April 1, 2019
BOARD OF COUNTY COMMISSIONERS
ORANGE COUNTY, FLORIDA
Addendum No. 2, IFB Y19-744-RC
MAGNOLIA PARK & ECO-TOURISM UTILITY EXTENSION

ELECTRICAL - PANEL SCHEDULES
 UTILITY EXTENSION
MAGNOLIA PARK ECO-TOURISM
 OC CAPITAL PROJECTS
 ORANGE COUNTY, FL

LIFT STATION DETAIL SHEET
 UTILITY EXTENSION
MAGNOLIA PARK ECO-TOURISM
 OC CAPITAL PROJECTS
 ORANGE COUNTY, FL

LIFT STATION PLAN AND DETAILS

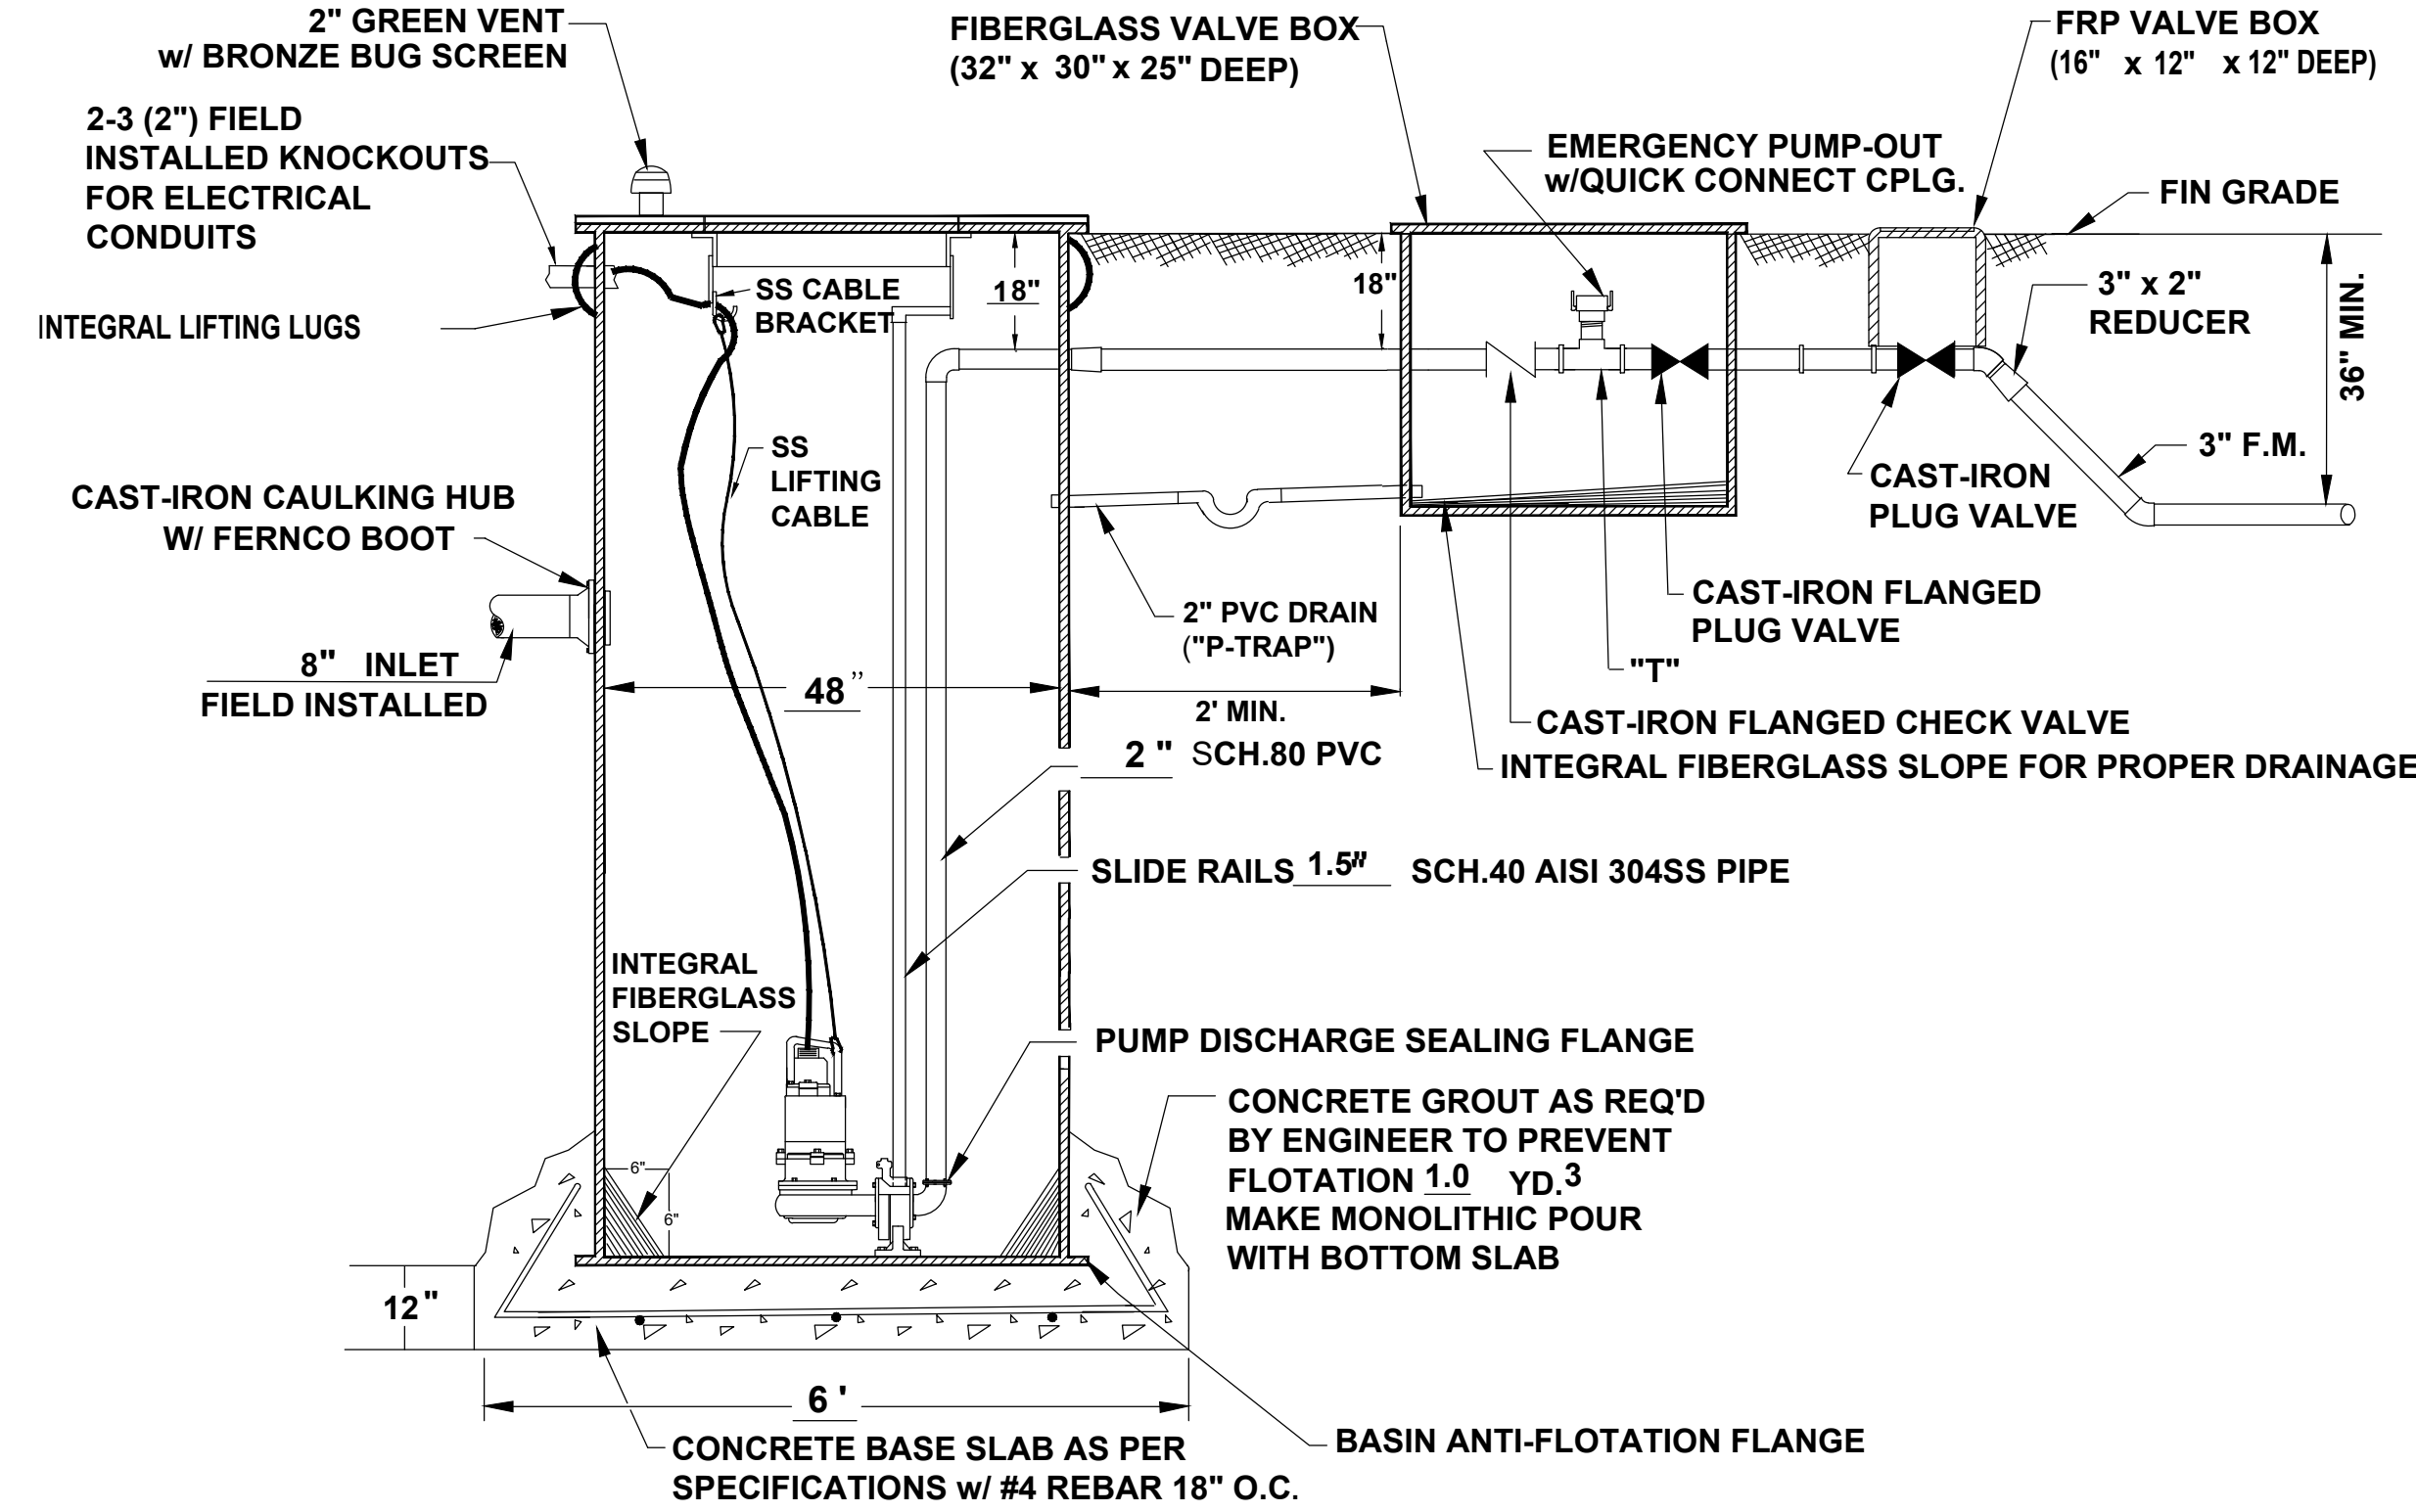
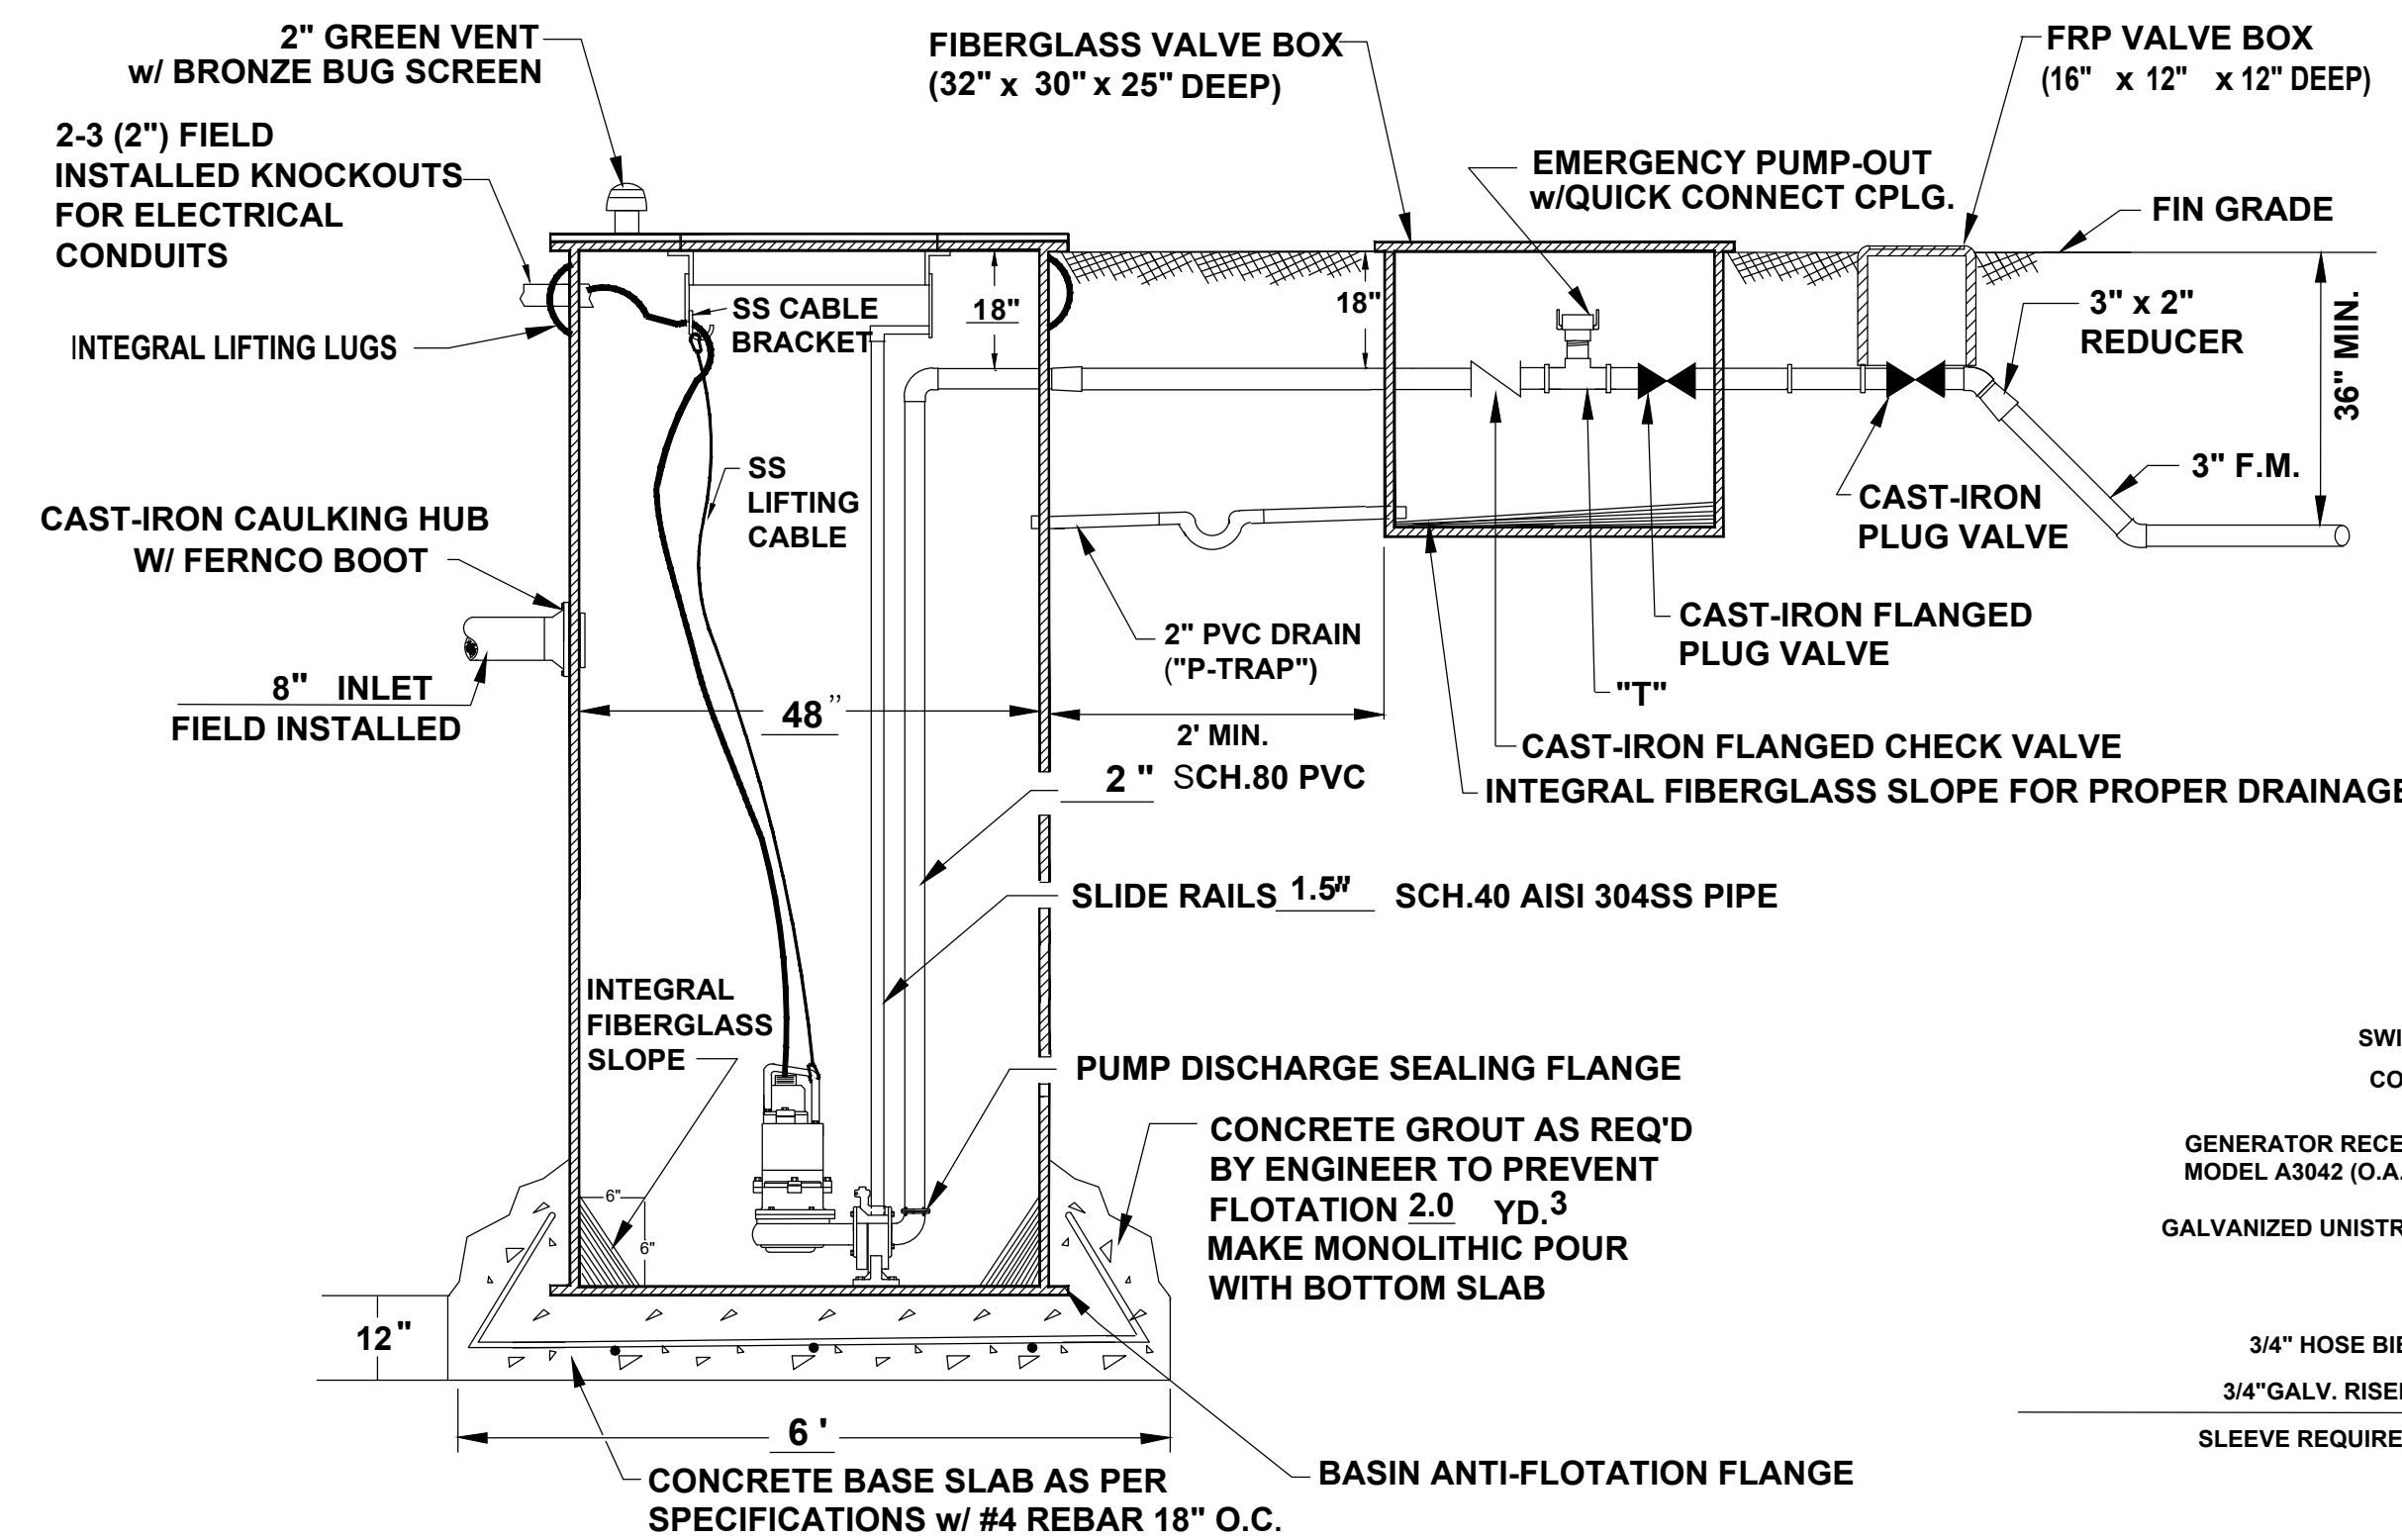
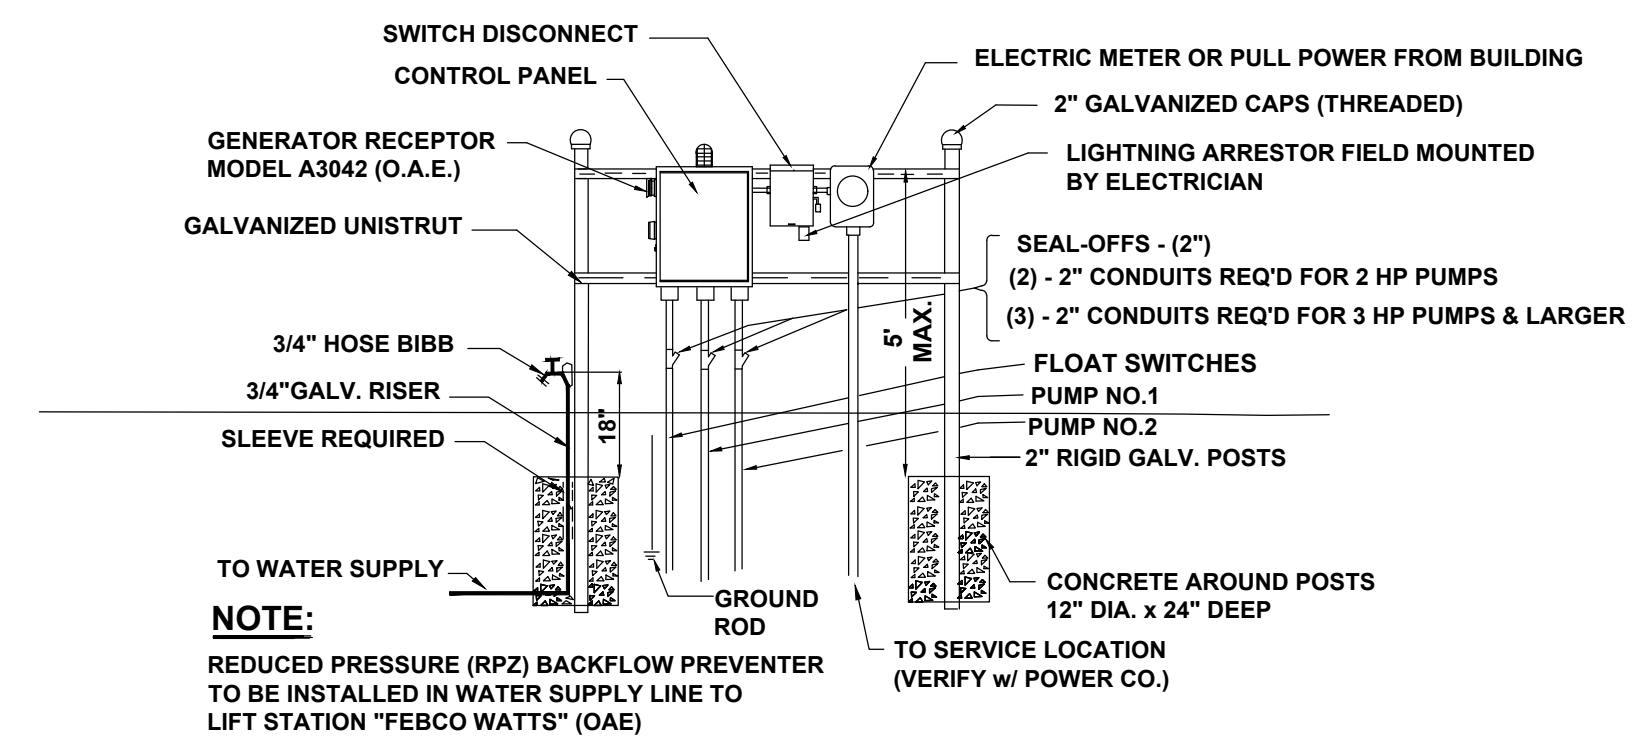
1. **Question:** On plan sheet C404, please confirm the uni-strut, caps and posts are to be galvanized and not stainless steel.

Answer: Please see revised Sheet C404 dated 3/25/2019 and labeled this addendum as noted below in part C
